WELCOMES AND UPLANDS ROAD ASSOCIATION

Ref APP/L5240/W/22/3296060

Re: Proposed development at 37 Welcomes Road CR8 5HA: Demolition of the existing dwelling, erection of a two/three storey building to provide 9 residential units, with associated landscaped areas including parking, cycle and refuse storage.

Fig 1 : Application First Floor Plan, showing side windows and balconies.

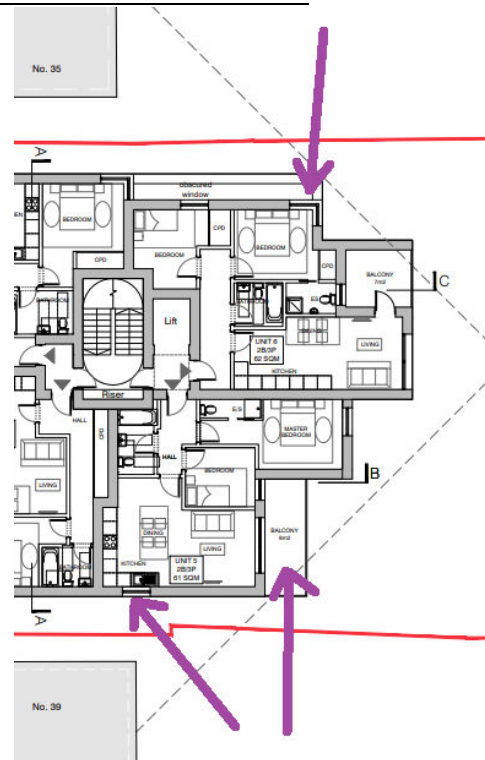
All upper storey side and rear facing windows will dominate the surrounding gardens. The balconies proposed at the back will also overlook the immediate neighbours, removing any sense of privacy. The plans clearly shows this, it is difficult to see how the applicant can back-up their statements that *“Balconies incorporated would not be overlooking. There would be no overlooking on the ground and first floor windows”* when the sight lines can clearly be seen on the applicant’s own diagram (Fig 1, opposite).
